SR-2 – ADVISORY STAFF REPORT (03-06-2026)

ADDRESS: 19170 WARRINGTON

APPLICATION NUMBER: HDC2025-00648

SCOPE: REMOVE FAÇADE BALCONY (WORK COMPLETED WITHOUT APPROVAL)

Designation photo, 2002. HDAB

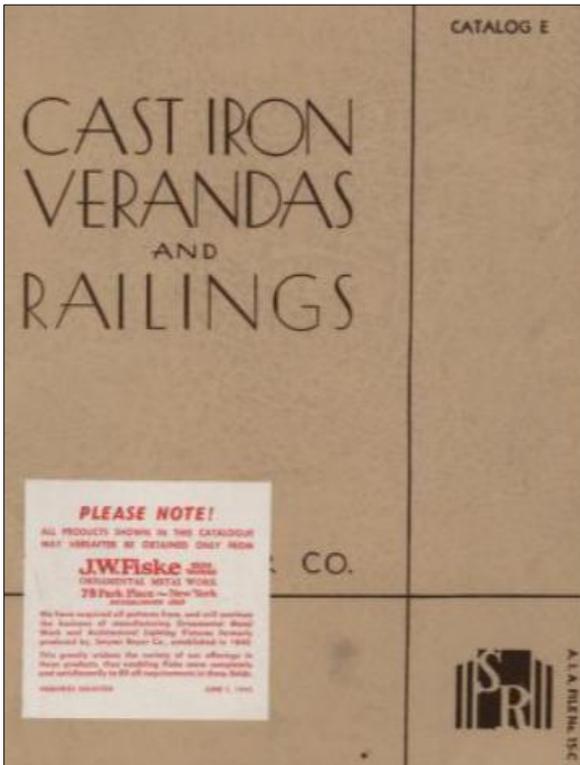
1. The front balcony was a distinctive, character-defining historic feature that dates to the resource’s time of construction and the district’s Period of Significance.

2. The distinctive feature demonstrated a mid-century approach for a balcony structure on a modern-designed dwelling and was materially and proportionally compatible with the dwelling’s metal framed windows.

Ornamental Ironwork catalog, Tennessee Fabricating Company (1955).

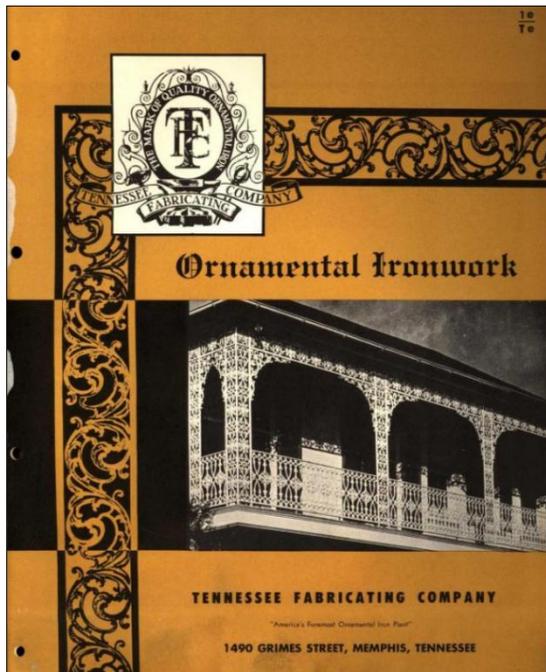
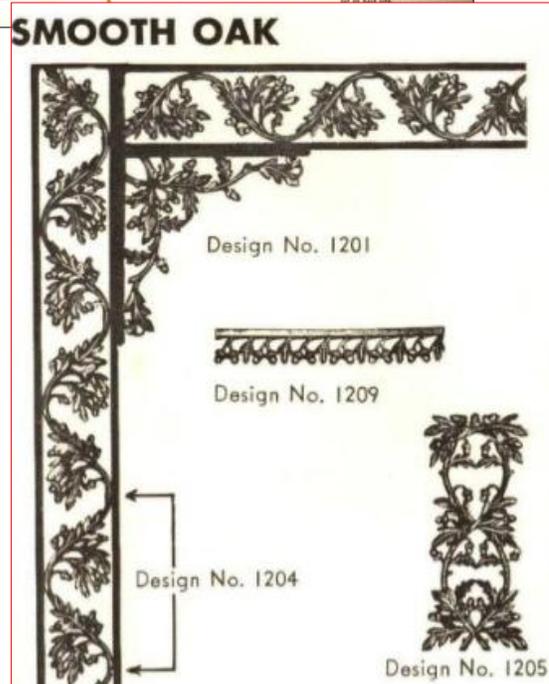
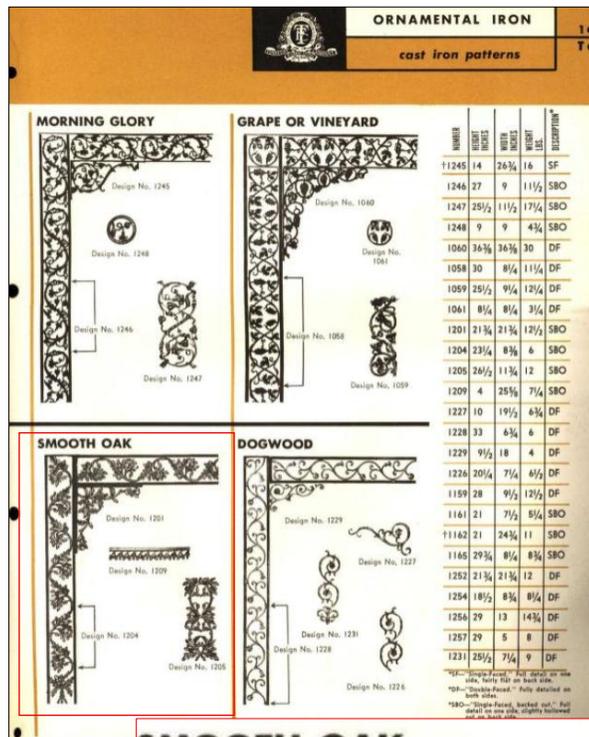
- Not only used for new construction, this type of post and railing proliferated throughout the city as a reasonably priced product to replace late 19th/early 20th century wood porch columns and railings as a way to “contemporize” older houses.
- Staff located the identical pattern of the metal posts and railing that was removed from this property (Smooth Oak, see image at right). Similar “oak” designs were found in the other 1950s and 1960s catalogs reviewed.

Photos from page 21 of the CNM Inspection Services Inspection Report. Inspection date: 12/20/2020.

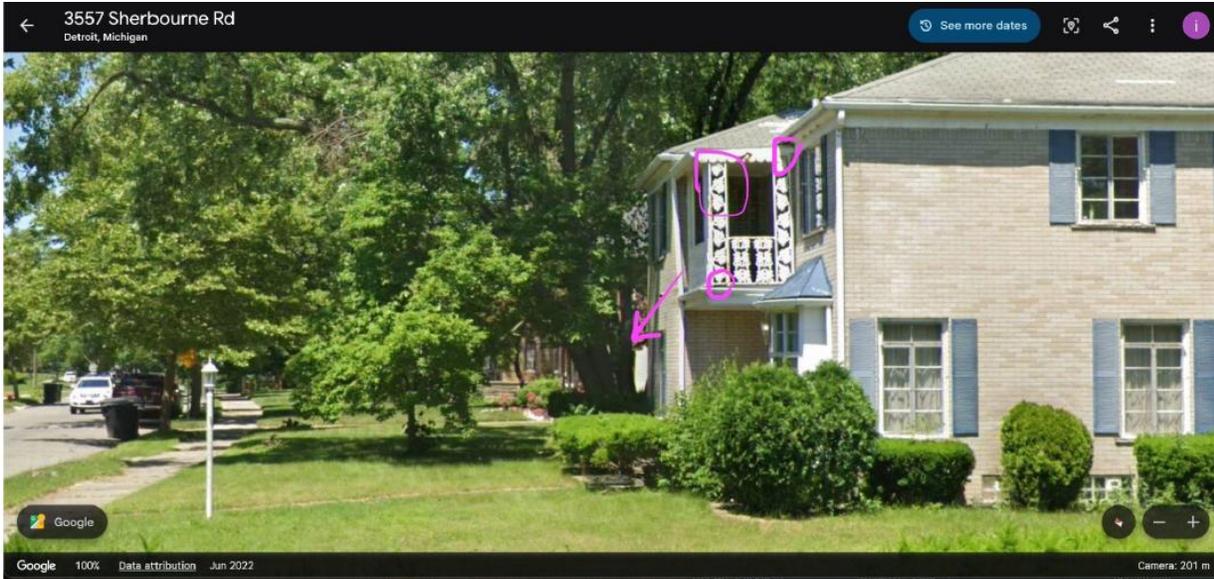
- The photos below were taken by a home inspector in December 2020 in preparation of a report created for the applicant. The photos shows a fully intact balcony structure, posts and railing. Surface deterioration is visible at one section of the scalloped trim that covers the post installations at the roof.
- The accompanying inspection report states on page 12, “*Spot decay/deterioration noted at upper porch support and rear window ledge repair and refinishing needed. These should be keep (sic) well sealed against the weather to prevent damage.*”

- The balcony was removed from the house in the fall of 2023, just under three years after the inspection was completed.
- The applicant claims that the balcony had deteriorated to the level of being unsafe and submitted a letter from a contractor, dated 11/24/2025, as part of this application.

Above and below: Google street view photos modified by the applicant.

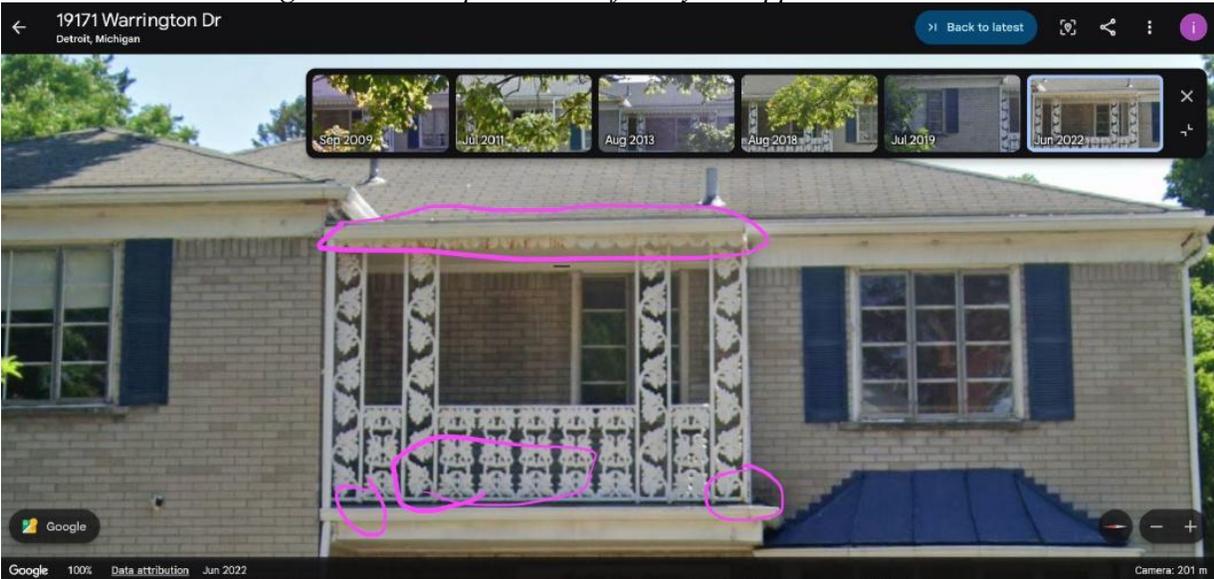
- During the review cycles for this application, staff made multiple requests for detailed photos of the balcony prior to its removal to substantiate the applicant’s claims that the components were unsafe and possibly deteriorated beyond repair. The only photos supplied by the applicant (outside of those within the inspection report) are shown on the following page.

- The original balcony, a distinctive-character defining historic feature, was removed without HDC approval; the scope of work that would meet the requirements of the historic ordinance (Section 21-2-59(e)) is the fabrication and installation of a new cast iron porch that matches the old.

4. The removal of the balcony altered the features and spaces that characterize the property. As the balcony was removed without HDC approval; the scope of work that would meet the requirements of the historic ordinance (Section 21-2-59(e)) is the fabrication and installation of a new balcony that matches the old in design, dimension, color, texture and material.
